Proposals from the Informal Working Group on AEBS to amend UN R152

**00 and 01 Series amendment of R152
GRVA-2020-17 (Robustness of the system)**

(GRVA-2020-17)

Car to Bicycle scenario

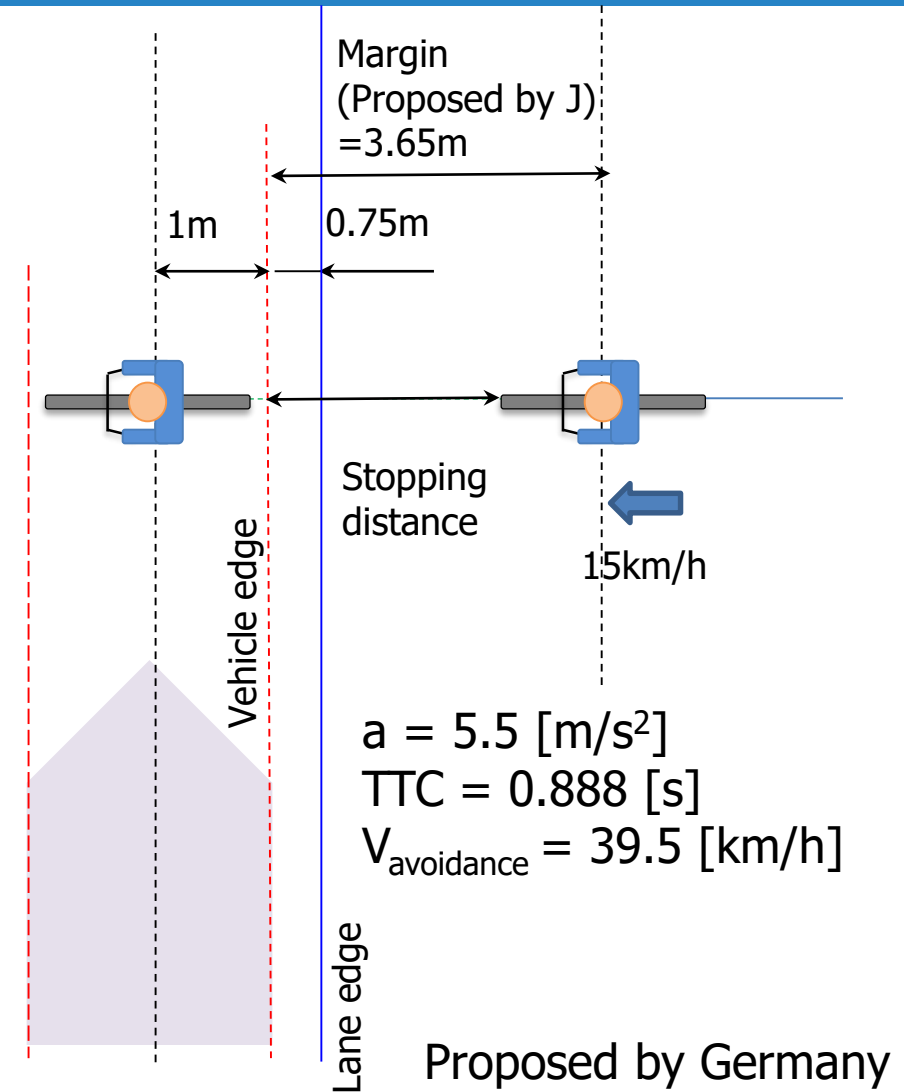
The group still faces difficulty in agreeing on performance requirements for the car to bicycle collision given the lack of vehicles with this technology on the market. Consequently, the informal working group agreed to consider car-to-bicycle at a later stage, when more data is available.

- Scenario of C2B
- Accident data
- Euro NCAP
- Lower Speed (LS) of Ego vehicle
LS = 20 km/h, LS = 35 km/h
- Reference point for requirements

We need further clarification

“GRVA agreed the extension of mandate to adequately address Car to Bicycle scenario (e.g. 7th GRVA - September 2020), when more data is available.”
